| Model: Katana-P1 (Bellini-P1) | Date: 09-Feb-09 | No.: RM002001g |
| Subject: Firmware Release Note: Engine | Prepared by: Y. | Tanimoto |

This RTB has been issued to announce the firmware release information for the Engine.

23.Toner Bank Unit 1 (M002/M003/M004)

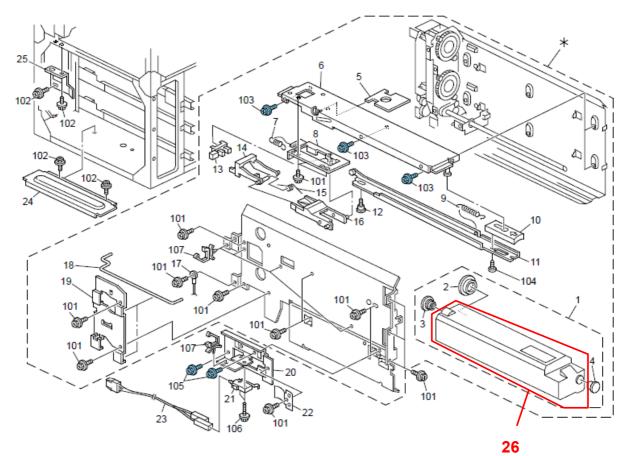
Change: A new service part has been added.

| New part number | Description | Q'ty | Int | Page | Index | Note |
|-----------------|--------------------------|------|-----|------|-------|------|
| B2343701 | COLLECTION BOTTLE: ASS'Y | 1 | I | 60 | 26 | |

32.Cleaning Unit 1 (M002/M003/M004)

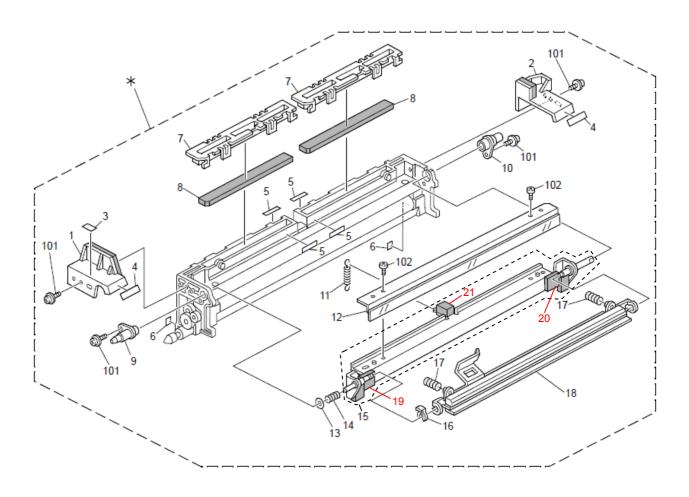
Reason: Due to request from the field.

| New part number | Description | Q'ty | Int | Page | Index | Note |
|--------------------|-----------------------------|------|-----|------|-------|------|
| B2343572 | SEAL:BLADE:FRONT:ASS'Y | 1 | - | 78 | 19 | Add |
| B2343575 | SEAL:BLADE:INNER BACK:ASS'Y | 1 | - | 78 | 20 | Add |
| B2343578 | SEAL:BRACKET:BLADE | 1 | - | 78 | 21 | Add |

Finisher shift tray

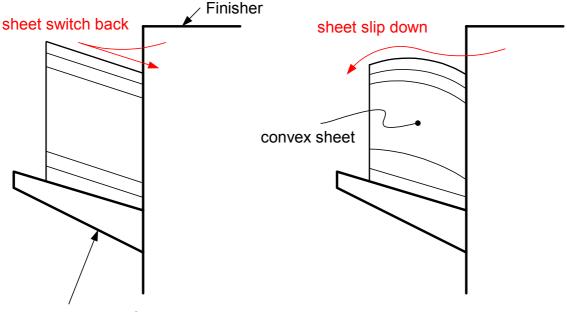
When convex-curled sheets are stacked on the Finisher shift tray, they could slip down from the tray to the ground.

The exited sheets are switched back on the Finisher shift tray, which is at an angle. However, when the sheets have convex curl and are stacked in a large amount, the slope becomes flat at the top of the stack. The flat stack stops the exited sheets from switching back and causes them to slip over due to their momentum.

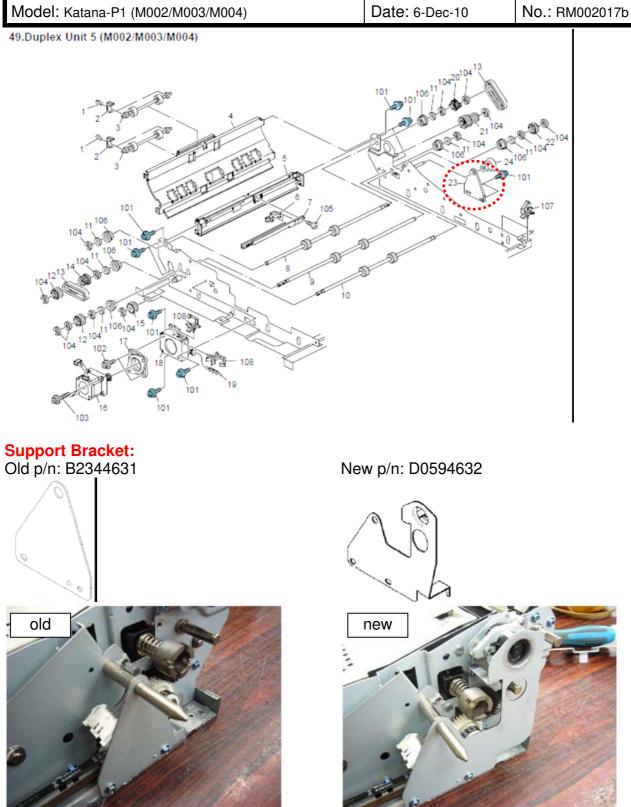
The support bracket has been modified (B2344631 \rightarrow D0594632) to prevent the possible breakage of the gear, which has also been modified for higher durability (B2344649 \rightarrow D0594649).

The duplex unit also has a new p/n because of this modification.

- Replace the gear (B2344649) with the modified gear (D0594649) if it breaks.
- If the breakage were to recur, please replace the duplex unit with the modified duplex unit installed with the NEW support bracket.
- The NEW support bracket (D0594632) cannot be installed on the old duplex unit (X/X).

D0596200 → D0596201 PAPER FEED UNIT:PAPER BANK:ASS'Y 15.Paper Feed Unit 1 (M002/M003/M004)

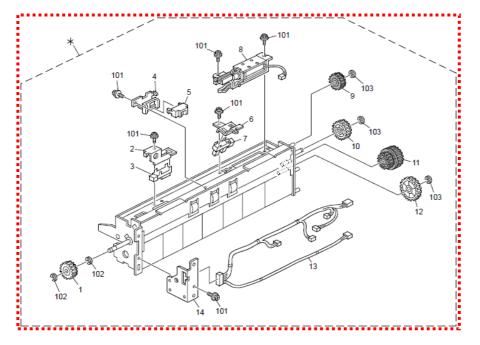
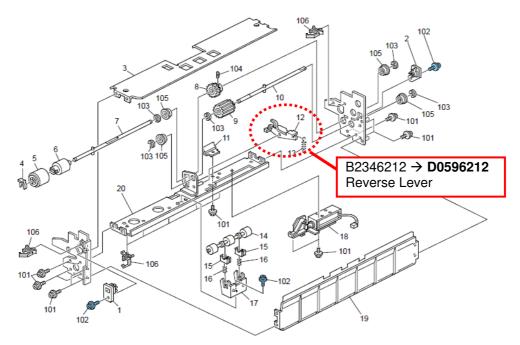
Change: Shape and position of components in the paper feed unit **Reason:** Higher reliability; to prevent mis-feed jams in the paper feed unit

Insufficient pressure between the Feed and Reverse rollers could result in mis-feed jams. The shape of the component in the paper feed unit and the reverse lever have been modified, and the Reverse roller has been raised to a slightly higher position to maintain the optimum pressure between the two rollers.

8.Operation Panel 4 (M002/M003/M004)

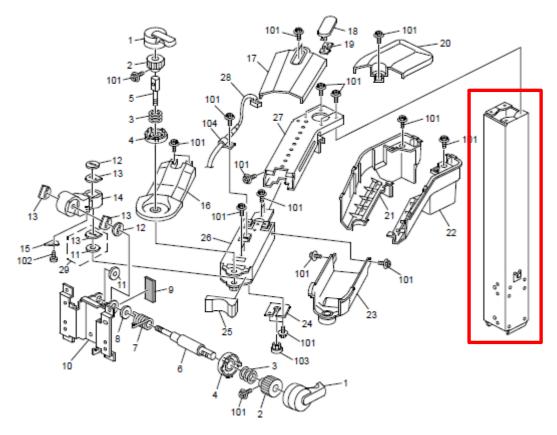
Change: Parts Catalog Correction **Reason:** Missing from the Parts Catalog.

| New Part Number | Description | Q'ty | Page | Index | Note |
|--------------------|------------------------------|------|------|-------|------|
| M0021433 | FRAME:ARM:OPERATION SUB-UNIT | 1 | 31 | 30 | Add |

Old

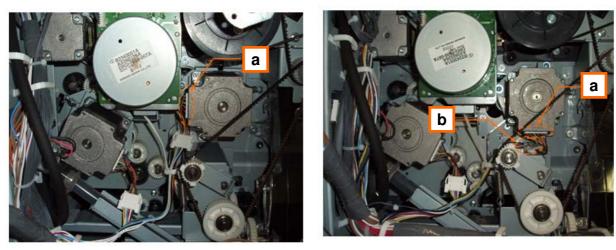
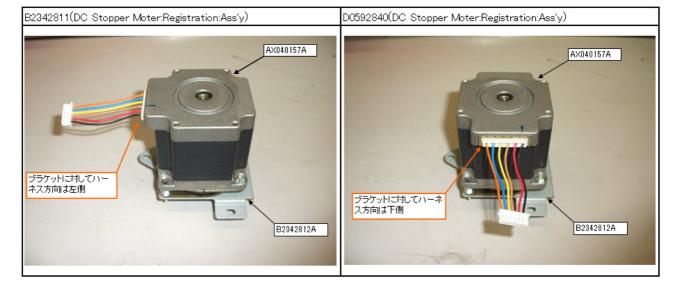
Change: a) Orientation of the DC Stepper Motor; 90 degrees counterclockwiseb) Addition of a clamp (in accordance with the change in the motor orientation)

Reason: To prevent possible damage to the registration motor harnesses

NOTE: The newly added clamp is immediately below the harness connector of the motor indicated with the blue circle in the diagram below, and attaches to a bracket that is not registered as a service part.

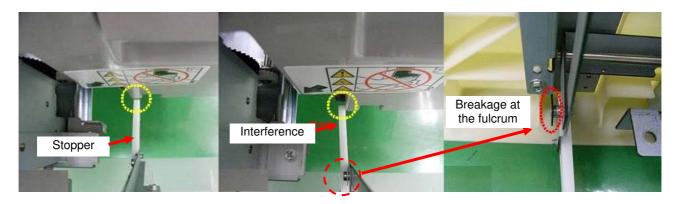
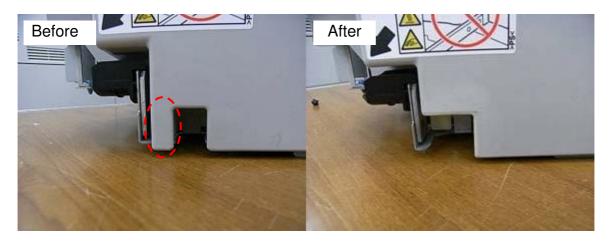
Change: Shape of the tandem tray inner cover

Reason: When closing the tray, the tip of the white plastic stopper (p/n: D0596702) could interfere with the tandem ray inner cover and damage the fulcrum of the stopper, disabling proper set of the tray.

The bottom corner of the INNER COVER: TANDEM LCT (indicated with a red circle in the photo below) was cut out to prevent the stopper from interfering.

2.Exterior 2 (M002/M003/M004)

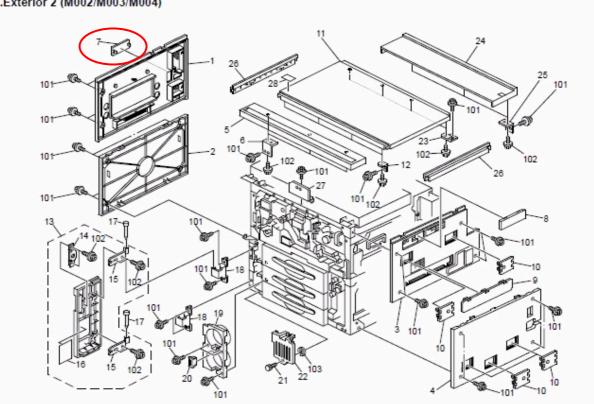
Change: The connector cap used commonly for the Cover Interposer Tray CI5000 and LCIT RT5030 / 5040 was eliminated.

| Old Part Number | New Part Number | Description | Q'ty | Int | Page | Index | Note |
|--------------------|--------------------|---------------|------|-----|------|-------|------|
| B2341341 | - | CAP:CONNECTOR | 1 | - | 19 | 7 | - |

62.Electrical Section 4 (M002/M003/M004)

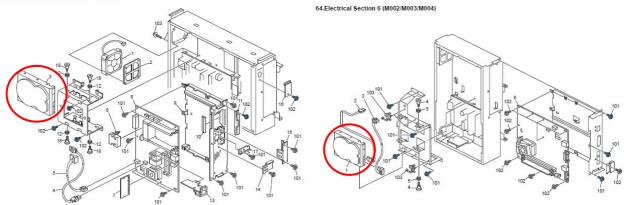
Change: P/N of the HDD was changed. **Reason:** Change in the vendor.

| Old Part Number | New Part Number | Description | Q'ty | Int | Page | Index | Note |
|--------------------|----------------------|---|------|-----|------|-------|------|
| D0895765 | D0295792 | HDD:WD:160GB:63N9A0 | 1 | X/O | 139 | 3 | - |
| D0895765 | D0295792 M0026868 | HDD:WD:160GB:63N9A0 HDD:PROGRAM:IPDS:INNER ASSEMBLY:EXP | 1 | X/O | 143 | 1 | - |

62.Electrical Section 4 (M002:M003:M004)

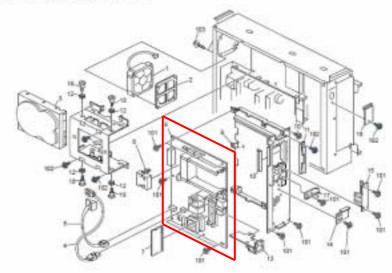
Change: The PCB Controller Board was registered with a new p/n.

Reason: The PCB Controller Board was modified to resolve the failure in activating the printer.

| Old Part Number | New Part Number | Description | Q'ty | Int | Page | Index | Note |
|--------------------|--------------------|-------------------------|------|-----|------|-------|------|
| - | M0025607 | PCB:B-P1A:SERVICE:ASS'Y | 1 | - | 139 | 19 | Add |
| - | M0035607 | PCB:B-P1B:SERVICE:ASS'Y | 1 | - | 139 | 19 | Add |
| M0045505 | M0045507 | PCB:B-P1C:SERVICE:ASS'Y | 1 | X/O | 139 | 8 | - |
| - | M0045607 | PCB:B-P1C:SERVICE:ASS'Y | 1 | - | 139 | 19 | Add |

73.Frame Section 3 (M002/M003/M004)

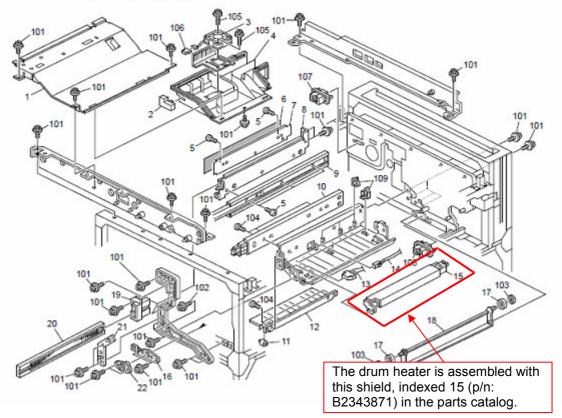
Change: The drum heater was registered as a new service part. **Reason:** For better performance of devices installed in highly humid regions

| Old Part Number | New Part Number | Description | Q'ty | Int | Page | Index | Note |
|--------------------|--------------------|------------------|------|-----|------|-------|------|
| - | AX400198 | HEATER - 240V/9W | 1 | - | 161 | 23 | Add |

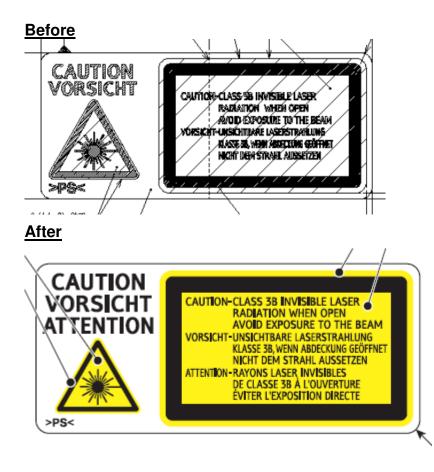
The laser caution decal was changed.

| Old part number | New part number | Description | Q'ty | Int | Page | Index | Note |
|--------------------|--------------------|-------------|------|-----|------|-------|------|
| G0291982 | G0291980 | DECAL - LD | 2 | 2 | 33 | 1 | |
